COVER SHEET  
FOR  
**PUYALLUP PUBLIC SAFETY BUILDING**

PRCCP20030372  
1st Review  
May 2025

COVER SHEET  
FOR PUYALLUP PUBLIC  
SAFETY BUILDING BENAROYA  
TENANT IMPROVEMENT PERMIT/BID SET

Sheet  
C9 of 9

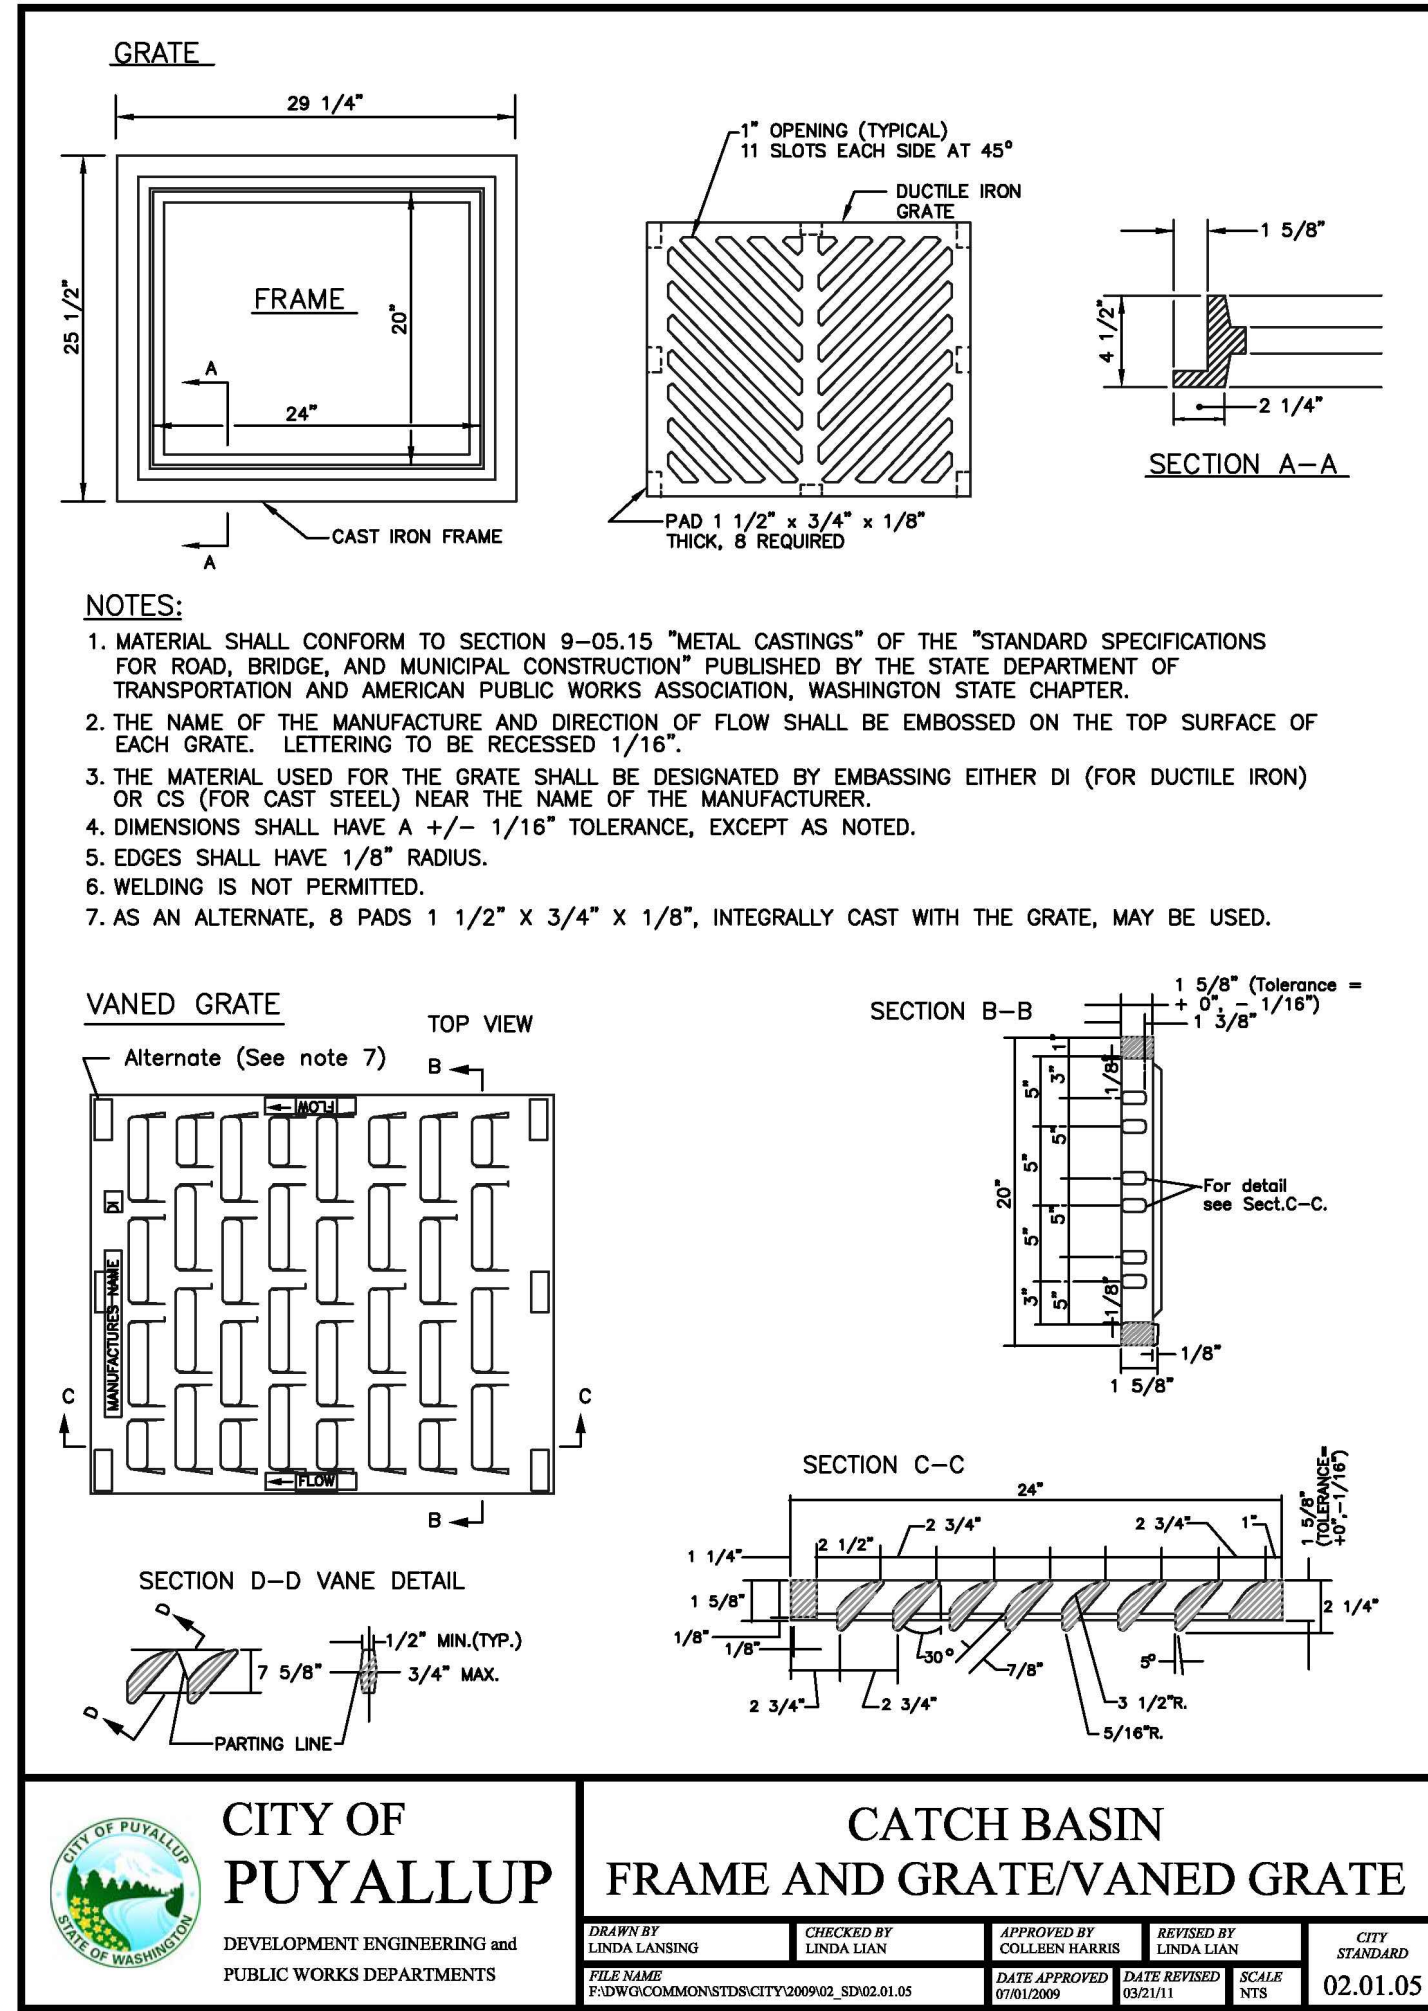
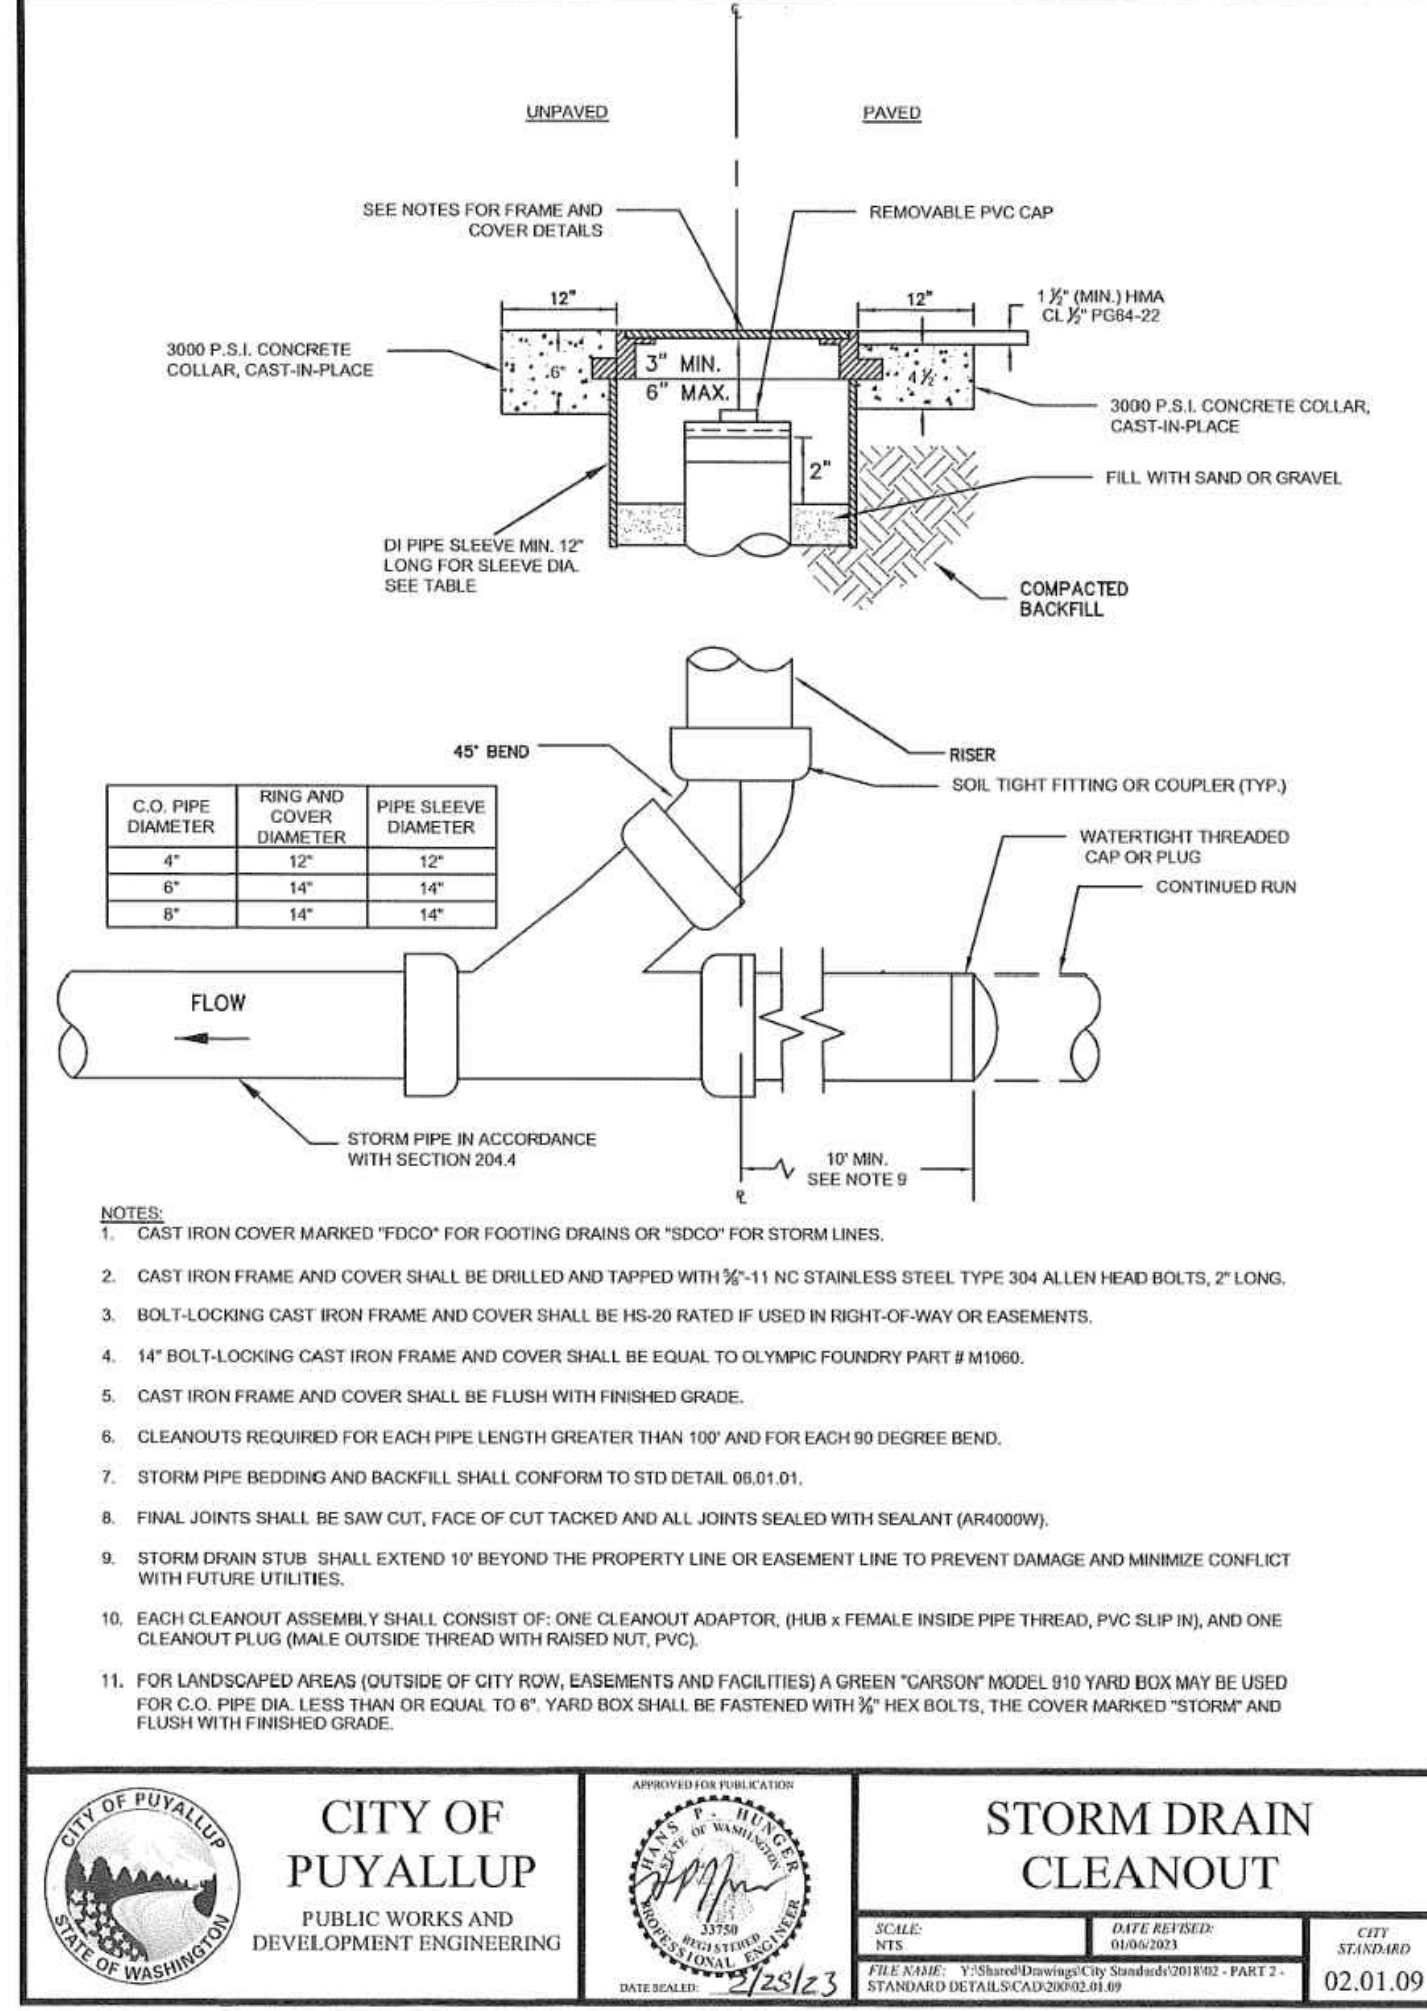
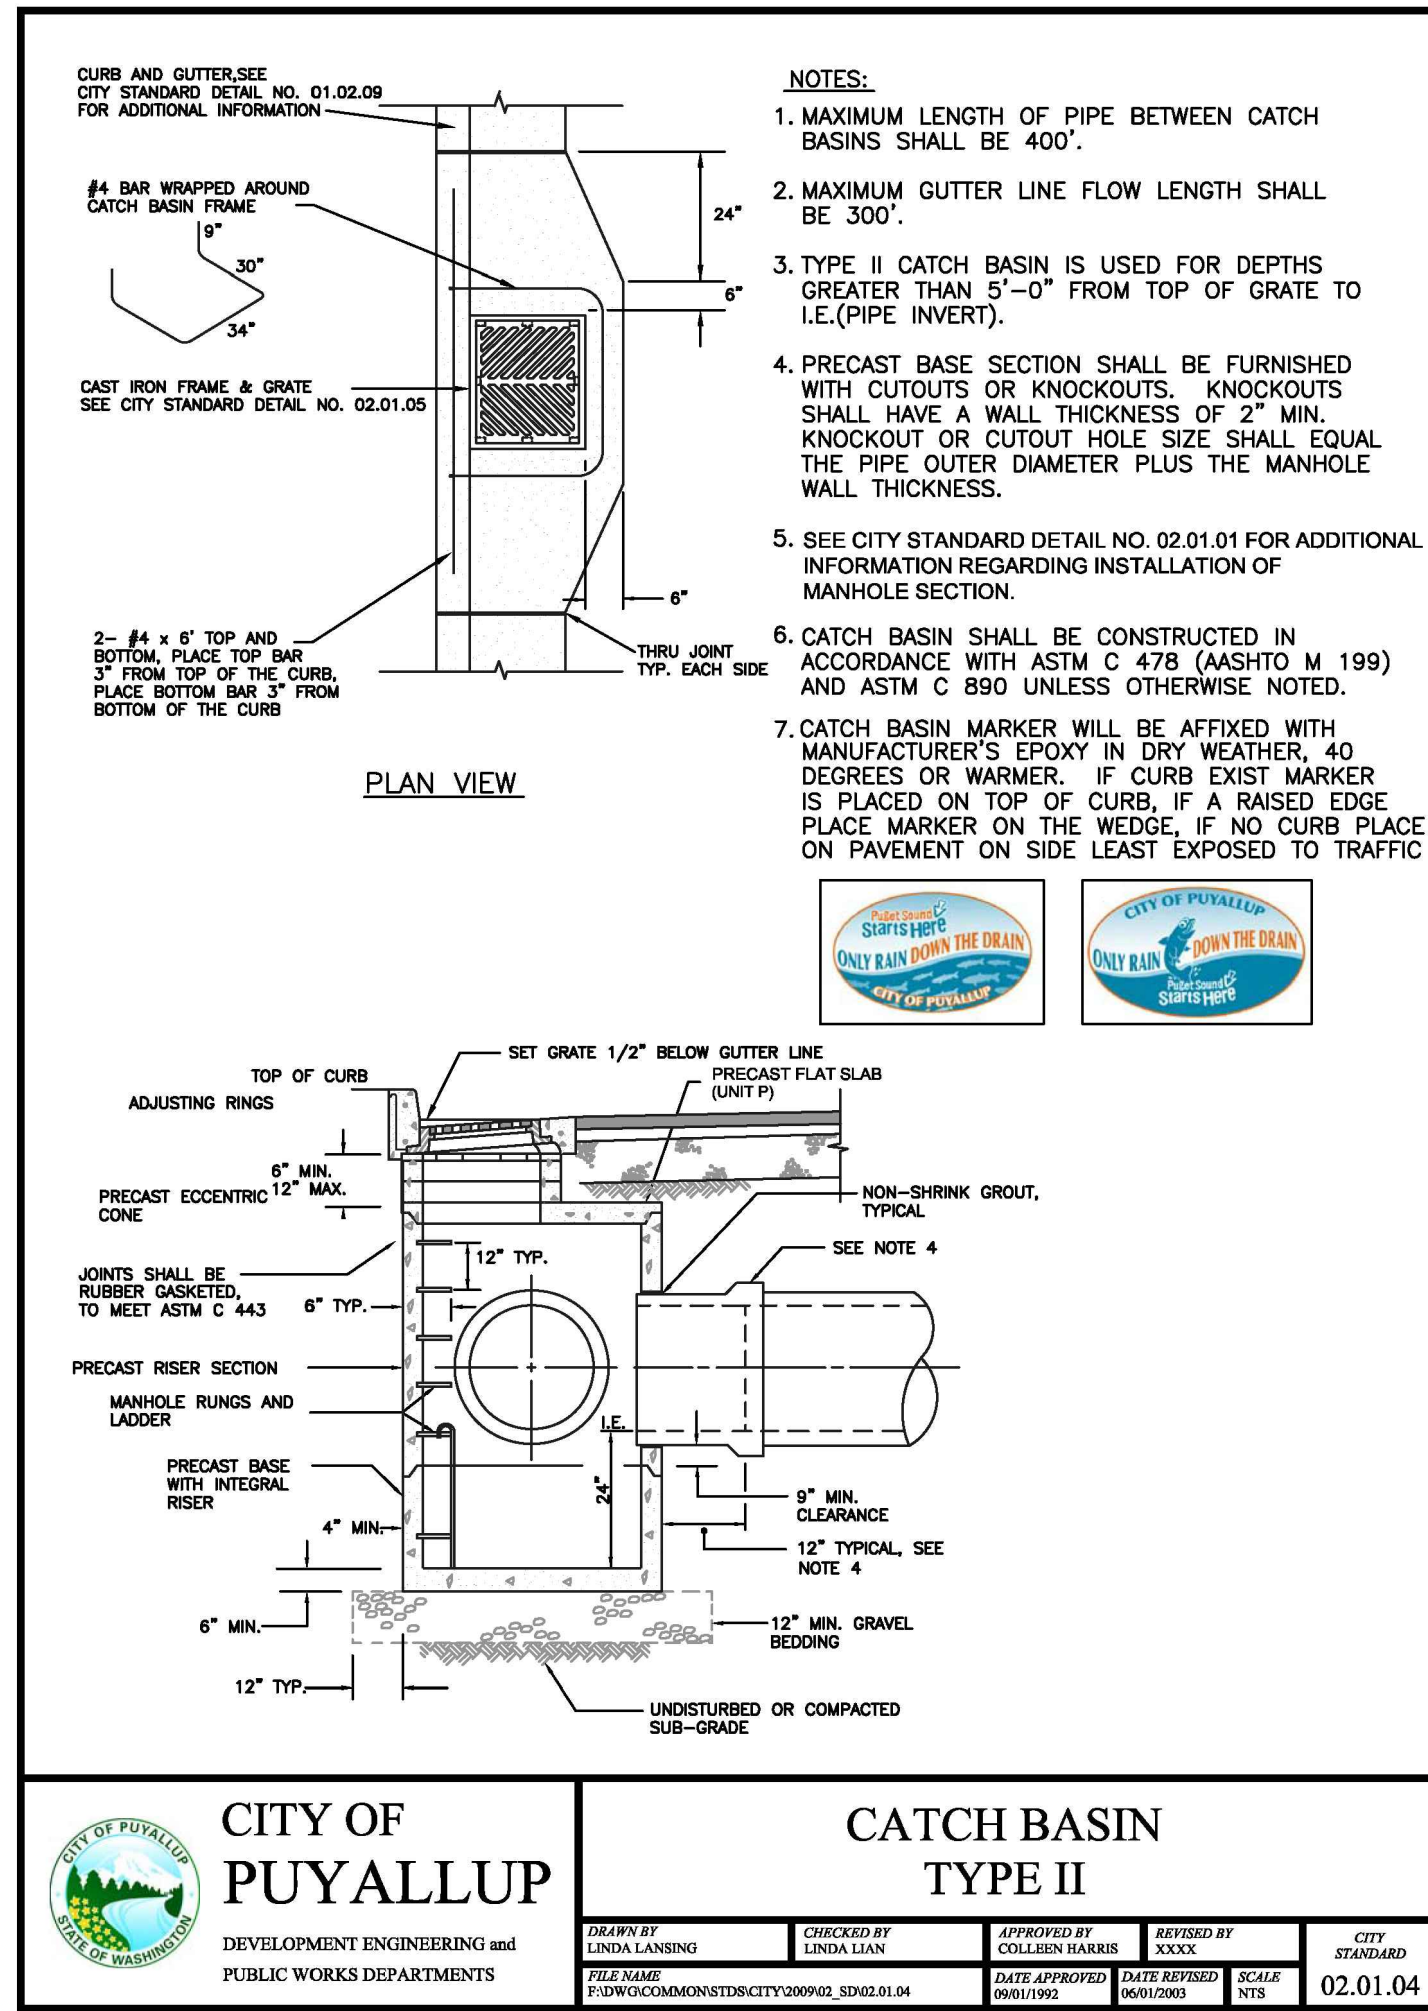
Add City Standard Details:  
06.01.02

DETAIL  
ADDED
